# Planning and Development (Plan Variation No 344) Approval 2018

**Notifiable instrument NI2018-430**

# Variation to the Territory Plan No 344

Woden Town Centre:  
Zone changes and  
amendments to the Phillip  
precinct map and code

Figure 3: Areas subject to rezoning

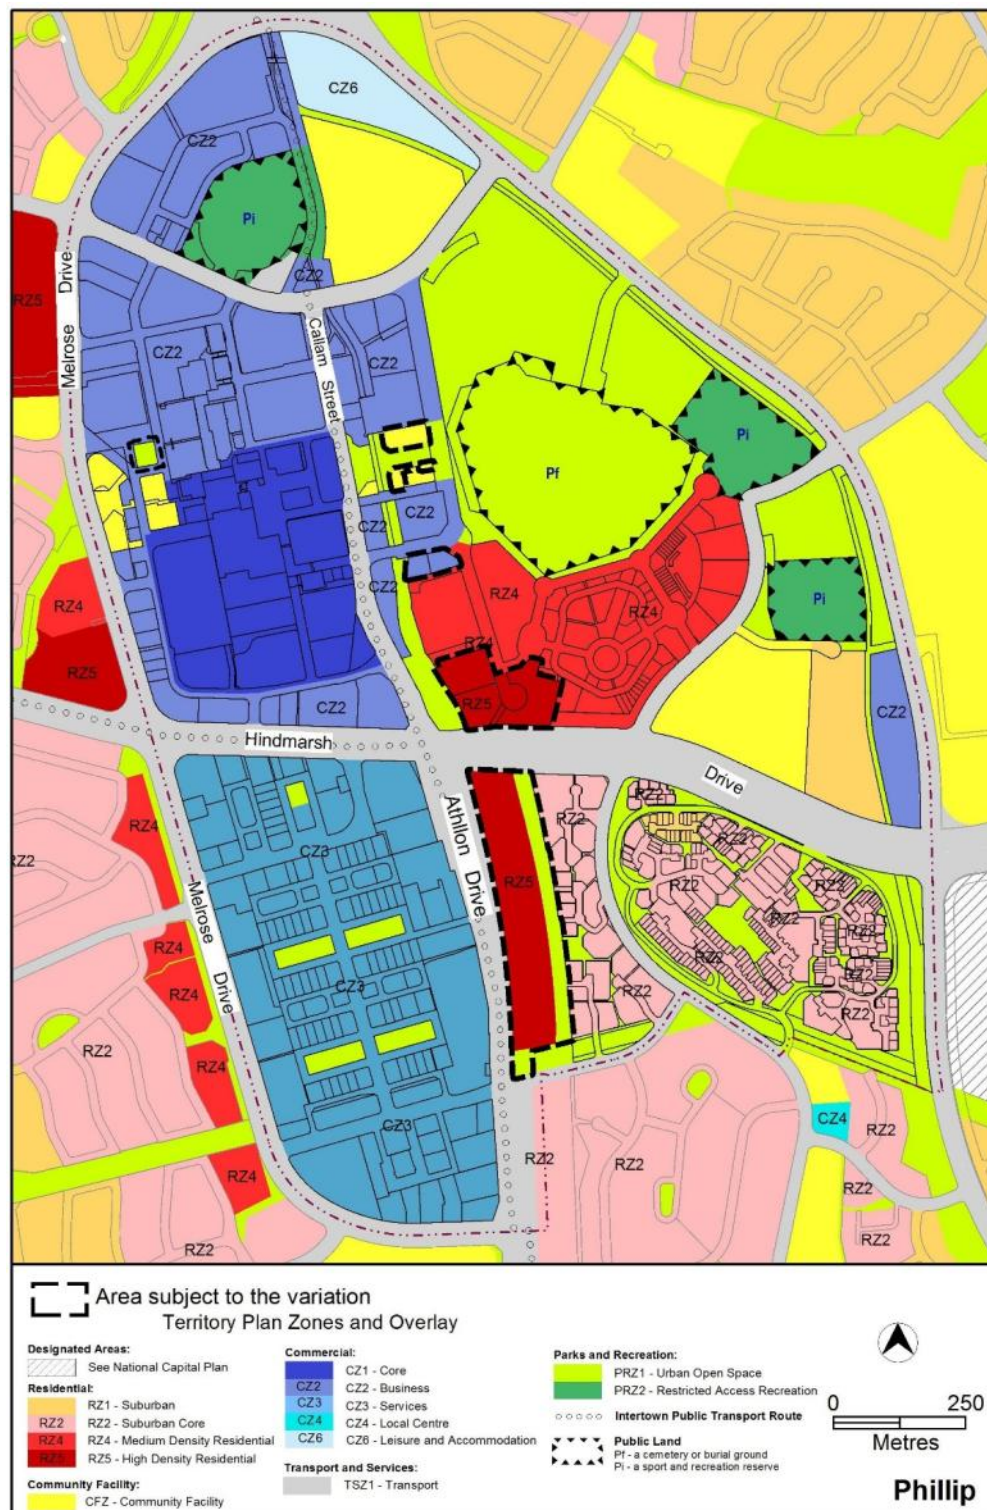
The Territory Plan map is varied as indicated in figure 3.
